**ARB2 - Replacing Upper Trailing Arm on the Front Axle (Recall Campaign)**

Revision: This bulletin replaces bulletin Group 4 122/24 ARB2, dated August 14, 2024.

Model Line: **Cayenne (9YA / 9YB)**

*Installation position of front trailing arm upper left*

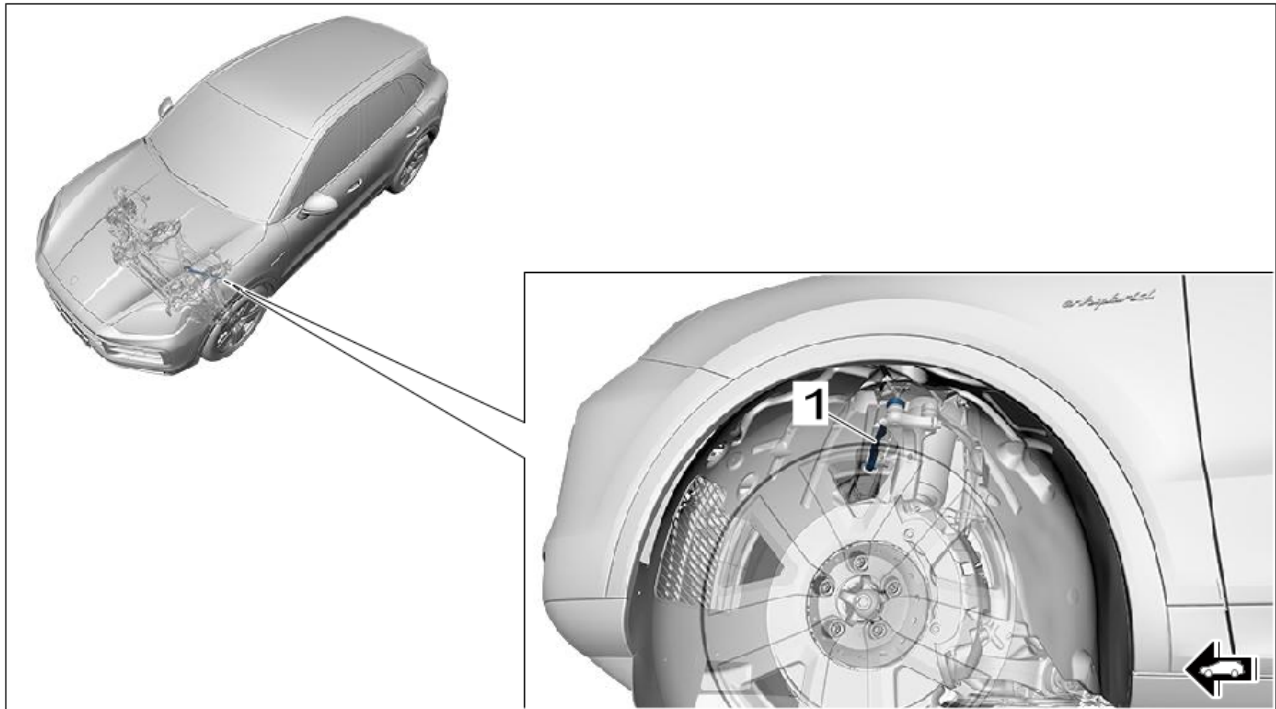
Cause: **There is a possibility that trailing arms on the front axle (top front left) on affected vehicles do not meet the required specifications.**

If this is the case, the trailing arm of the axle may break in the course of the vehicle's service life. A fracture in the trailing arm would cause impairment in steering. A potential loss of control of the vehicle cannot be ruled out if this happens. This can increase the risk of accident and injury.

Action: Replace upper trailing arm (front left) on the front axle.
